City of Slidell, Louisiana
Planning Commission
Agenda

1818 McKinney Design Exception, Storage Facility

Case No. V22-26

Request: Design Exception front elevation
and entryway

Figure 1: Proposed Parcel A

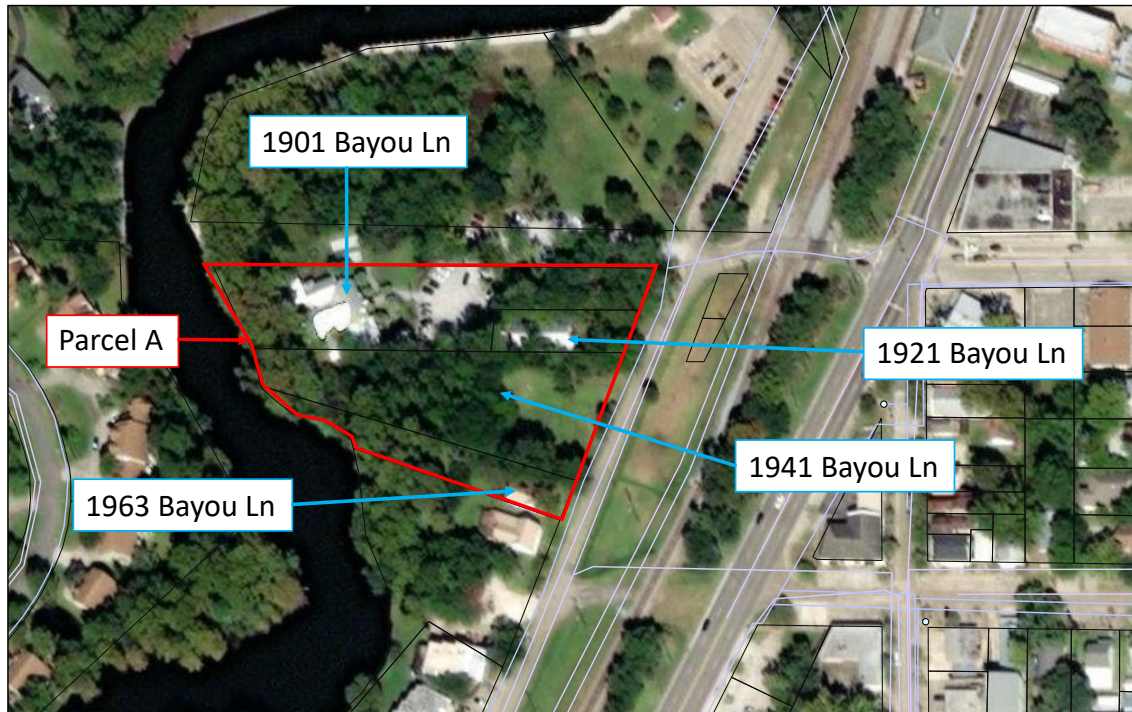
D. *Public Infrastructure* (Figure 1) includes:

- 1) *Water*. A City water line runs across property frontage in the Bayou Ln. right-of-way or ROW.
- 2) *Sewer*. A City sewer line runs across property frontage in the Bayou Ln. ROW.
- 3) *Drainage*. Properties drain directly into Bayou Bonfouca or to a City maintained drainage swale along Bayou Ln.
- 4) *Gas, Electric, Internet/phone*. Available from the Bayou Ln. ROW.
- 5) *Access*.
 - a) Currently four of the five parcels have frontage on Bayou Lane, a public ROW. The remaining 0.53-acre parcel having no municipal address is landlocked and has no access to a public ROW.
 - b) Proposed "Parcel A" will front on Bayou Ln., which is a City maintained street that connects to Fremaux Ave/US 190.

- B. Proposed "Parcel A" would have frontage on a City ROW with access to public utilities, including sewer, water, electricity, and gas (Figure 1).
 - C. Proposed "Parcel A" would not create any substandard lots or parcels nor would it create any "landlocked" lots or parcels requiring servitudes to access public infrastructure (Figure 1).

- D. Approval of Parcel A would rectify the existing unaddressed, substandard 0.53-acre parcel that currently lacks frontage on a public ROW.
 - E. Proposed "Parcel A" would not require any new public improvements nor would it require the extension or expansion of the capacity of the existing public infrastructure (Figure 1).

3. *Recommendation*. The Final Plat for Parcel A (application S22-04) be approved conditioned upon concurrent City Council approval of the associated rezoning application.

Figure 2: List of Architectural Details

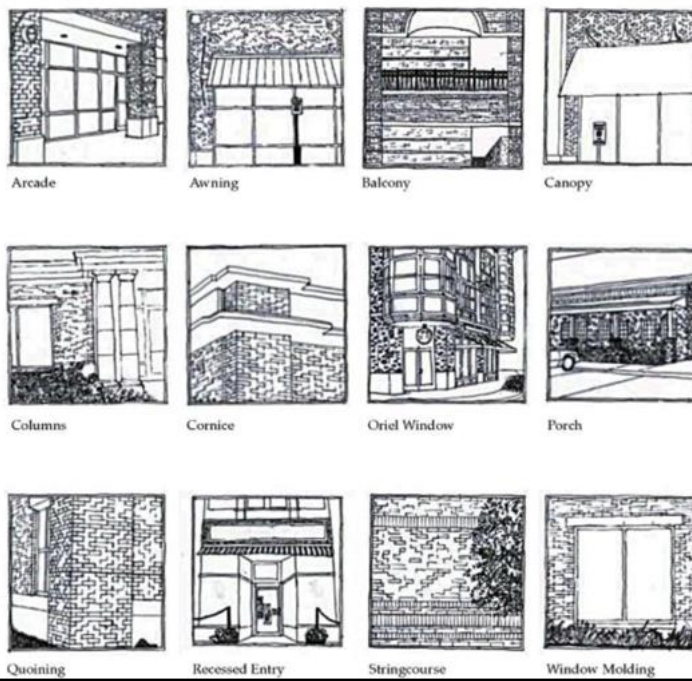
- i. *Requirement.* All buildings shall include a minimum of two (2) architectural details that promote and are in harmony with the design vernacular including but not limited to the list provided in Figure 2 of this Staff Report.
- ii. *1818 McKinney Design.* The building has a distinct ground to roof-line curtain wall glass façade inter stepped between sections of wall consisting of bands of weathered concrete masonry units (or CMU) and stucco separated by a smooth metal accent band. Decorative exterior lighting fixtures were added to front/street facing elevation. These architectural details together qualify as one of the two required architectural features (Figure 3 and Plan sheet A4.1 and A4.2). A second architectural feature is needed to meet the requirement.
